# Revision 7 Hardware Update

DMP is now shipping 7800 Series Keypads with Revision 7 hardware (PC-0132 R7).

New proximity read area

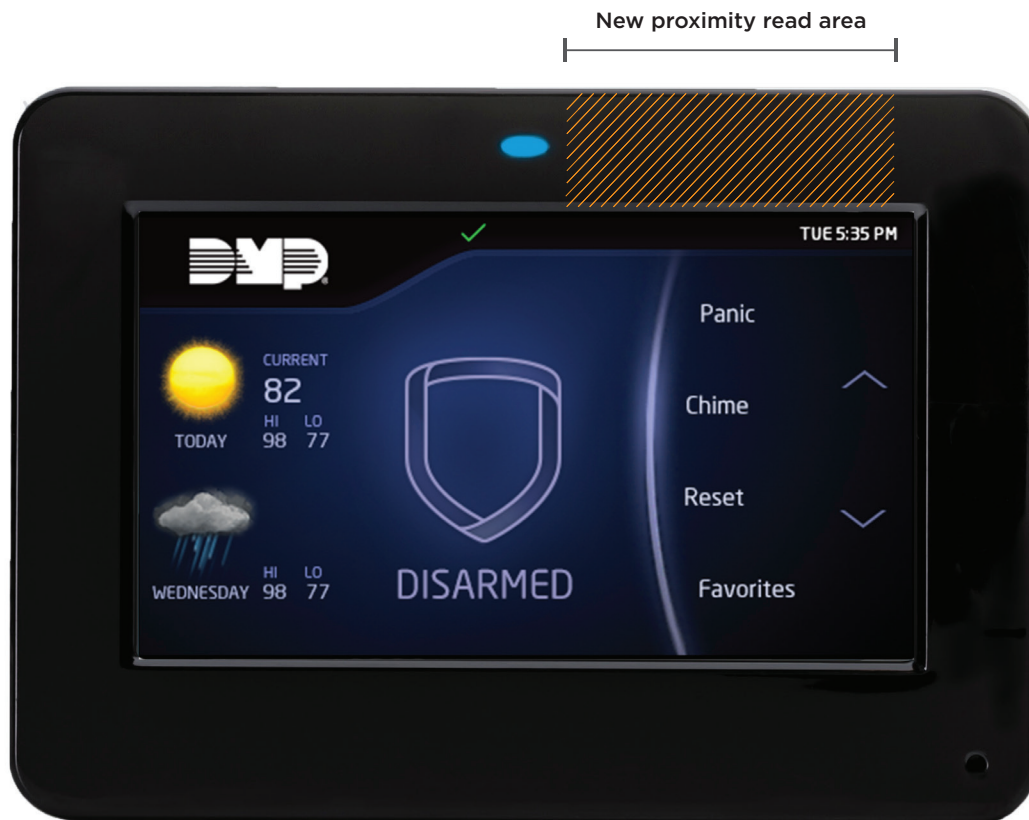
Updated Proximity Reader Antenna

We have updated the keypad prox reader's internal loop antenna with a chip antenna. The placement of the new antenna on the PCB changes where users must present a credential: At the top of the housing, to the right of the keypad LED.
